# UNITED STATES PATENT AND TRADEMARK OFFICE

APPLICATION NO.	FILING DATE	FIRST NAMED INVENTOR	ATTORNEY DOCKET NO.	CONFIRMATION NO.
10/783,172	02/20/2004	Mark J. Mayer	GLOZ 2 00163	7296
27885	7590	12/20/2005	EXAMINER	
FAY, SHARPE, FAGAN, MINNICH & MCKEE, LLP 1100 SUPERIOR AVENUE, SEVENTH FLOOR CLEVELAND, OH 44114			DZIERZYNSKI, EVAN P	
			ART UNIT	PAPER NUMBER
			2875

**Office Action Summary**

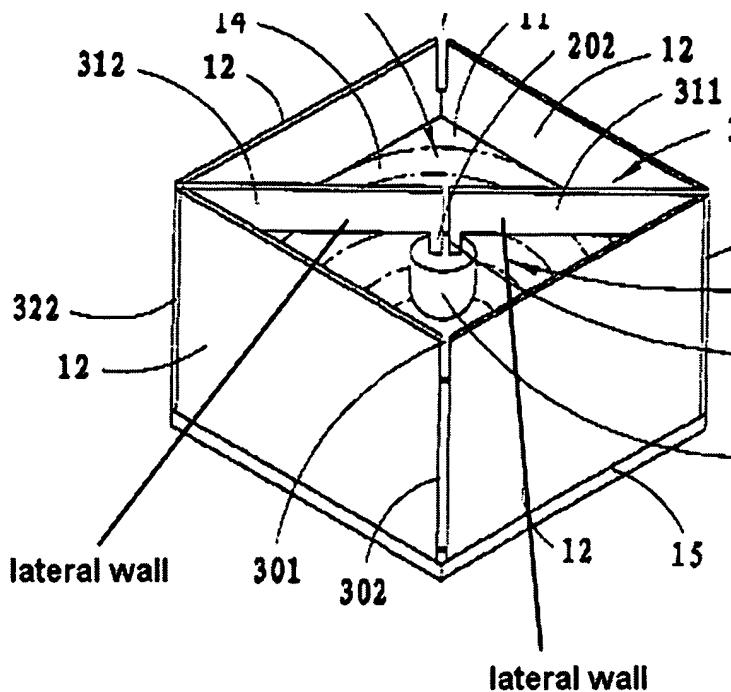
As for claim 9, Zhang teaches a lamp comprising a reflector 11. Zhang also teaches a support structure 12 which is above the reflector. Zhang further teaches a bridge 31 attached to the support structure, the bridge includes lateral walls depending toward the reflector (as indicated below). The lateral walls also include the reverse side of the indicated areas, which cannot be seen from the view in figure 1. Zhang also

teaches an LED 20 mounted to the bridge between the lateral walls such that the lateral walls act as a shield for the LED. The lateral walls of Zhang (indicated below) provide shielding to the same extent of the instant application. As the claim reads, the LED is mounted to the bridge between the walls. Because of punctuation, the claim does not say that the LED is between the lateral walls.

As for the arguments with respect to claim 14 dealing with the lateral walls not acting for a shield for the LED, this has been addressed in page 5 of the instant office action. The lateral walls indicated on page 6 do, in fact, shield the LED. The Applicant's argument that one skilled in the art would not modify Zhang such that the LED is mounted between the lateral walls as been considered, but is not persuasive since it is not necessary for the support arms to have an increased thickness to provide shielding for the LED, Zhang's device does in fact provide shielding for the LED.
